Subject: Duke Energy Carolinas, LLC
William States Lee III Nuclear Station – Docket Nos. 52-018 and 52-019
AP1000 Combined License Application for the
William States Lee III Nuclear Station Units 1 and 2
Response to Request for Additional Information (eRAI 2563)
Ltr# WLG2012.07-01

- 1) Lee Nuclear Station Supplemental Response to Request for Additional Information (RAI), Letter No. 068, RAI 03.08.05-005

Lee Nuclear Station Supplemental Response to Request for Additional Information (RAI)

Reference NRC RAI Number(s): RAI 03.08.05-005

Figure 1. Rectangular Foundation Area

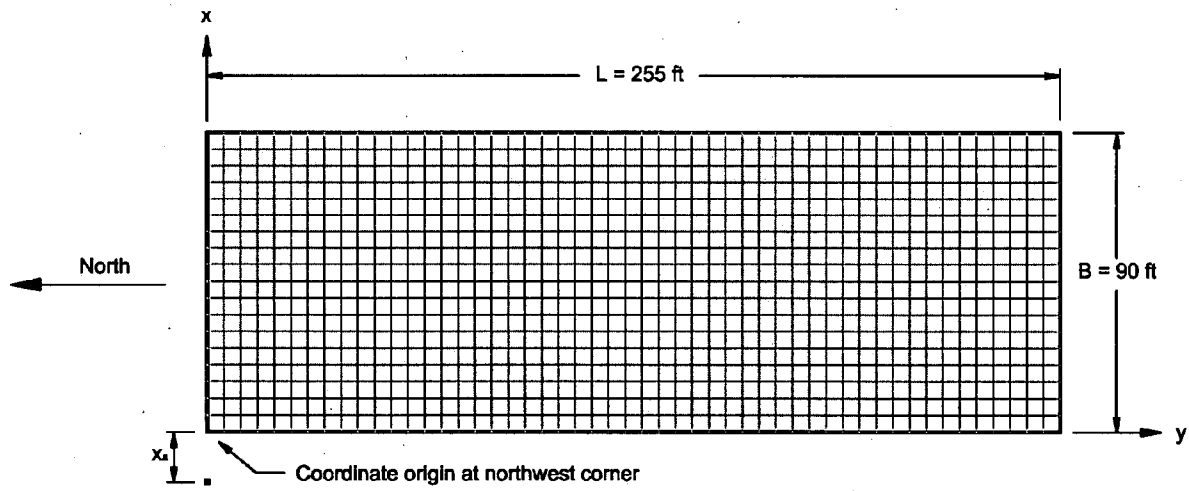
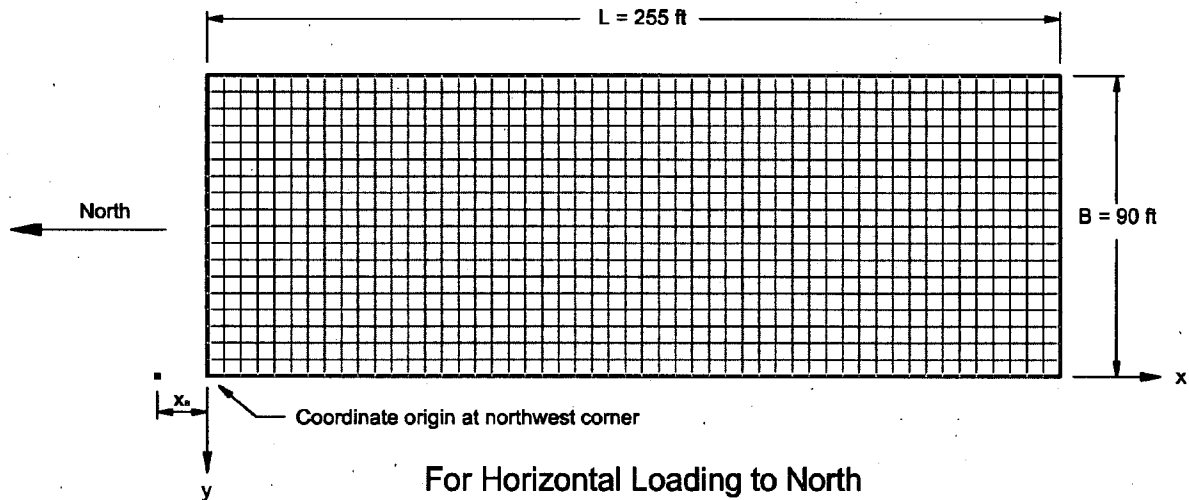
2. An analysis has been performed to verify that stress in the fill concrete is acceptable. The assumptions about the post-excavation geometry of the continuous rock, including the maximum slope of the rock are described below. The continuous rock begins to slope at the northwest corner of the Unit 1 nuclear island and slopes down to the north and to the west. The top of the continuous rock slope was kept at elevation 529.7 ft (20.8 ft below the base of the nuclear island) and a range of continuous rock slope angles was postulated from the flattest (4:1 H:V) to the steepest (0.25:1 H:V). The outer slope of the fill concrete begins 6 ft north and 6 ft west of the nuclear island base mat and slopes downward to the north and to the west at (0.5:1 H:V) and connects with the sloping continuous rock at elevation 500 ft as it is depicted on revised FSAR Figures 2.5.4-245 and 2.5.4-246, except where the postulated continuous rock slope is flat enough to intersect the outer slope at a higher elevation than shown on these figures. The plan view of the analyzed foundation model is depicted on Figure 1. The cross section geometric model is depicted on Figure 2, where alpha "α" is the symbol given to the rock slope inclination.

For loading to the north or to the west, an x-y-z rectangular foundation coordinate system, as depicted on Figures 1 and 2, was established for each direction with its origin at the corner of the nuclear island base mat and oriented so that the x-axis was always in the direction of the horizontal loading, with the z-axis always vertical and positive downward. Stresses were calculated at depths (z) below the bottom of the nuclear island ranging from 25 ft to the depth where each rock slope configuration intersected the outer slope of the concrete. For slope angles (alpha "α") equal to 1:1 (H:V) or steeper, the maximum depth was 50 ft; for flatter rock slope angles, the maximum applicable depth varied consistent with the depth where the rock slope angle intersects the outer slope (e.g. maximum depth = 25 ft for the flattest rock slope angle of 4:1 (H:V)). Equations from the theory of elasticity that compute the stress in the supporting medium for point loads on the surface as found in Poulos and Davis (1974) (Reference 5) and in Som and Das (2009) (Reference 6) were used to compute the normal and shear stresses induced by the horizontal and vertical foundation loads.

The equations for induced stresses are for point loads. The foundation area (Figure 1) is subdivided into small square sub-areas with the center of each square serving as the coordinate location of a point load representing the area load associated with that square. Sub-area squares, five ft by five ft, are used. The foundation area is represented by 51 rows of sub-area squares in the north-south direction, and by 18 rows in the east-west direction, for a total of 918 sub-areas covering a total area of 22,950 ft² (255 ft (north-south) by 90 ft (east-west)).

The rectangular shape and size of the foundation in Figure 1 are somewhat smaller than the full nuclear island area, but were chosen for calculation convenience, justified by the concept that seismic loading to the north or to the west concentrates the vertical loading toward these sides (e.g., see Figure 2.6-8 of TR-85, Revision 3) and that applied loads on the foundation area that is located far from the northwest corner are not contributors to the stress in the sloping fill concrete in that locality.

Figure 3. Stresses in Fill Concrete at Outer Slope

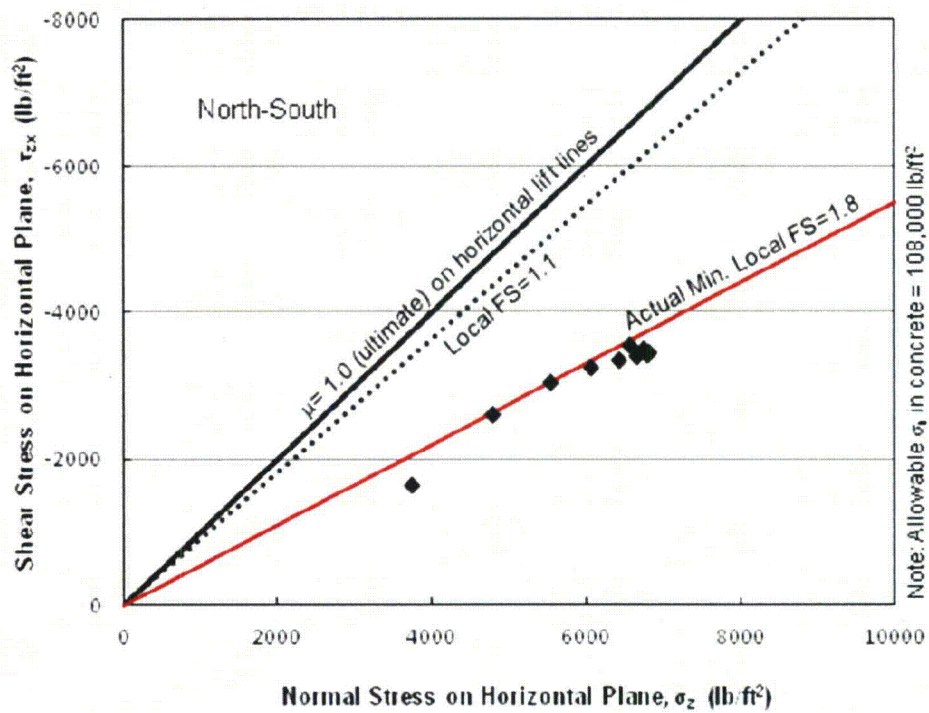
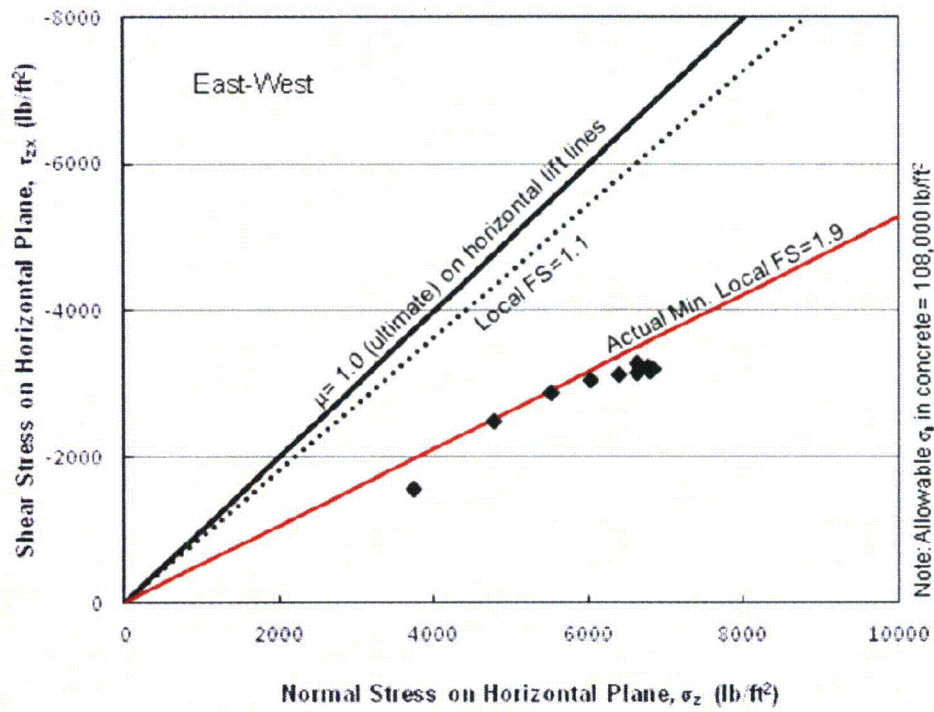
The fill concrete is an essential part of the foundation load path. Without a quantitative stress analysis that accounts for the sloping rock geometry, it is not apparent to the Staff that the margin of safety for the fill concrete in the northwest corner is acceptable.

- Revised Figure 3 depicts the normal (vertical) and shear stresses on horizontal planes along the outer slope of the fill concrete which is identified on Figure 2. Inspection of Figure 3 indicates the shear stresses on horizontal planes at the outer slope of the fill concrete are significantly below the descriptive criterion (local FS = 1.1).
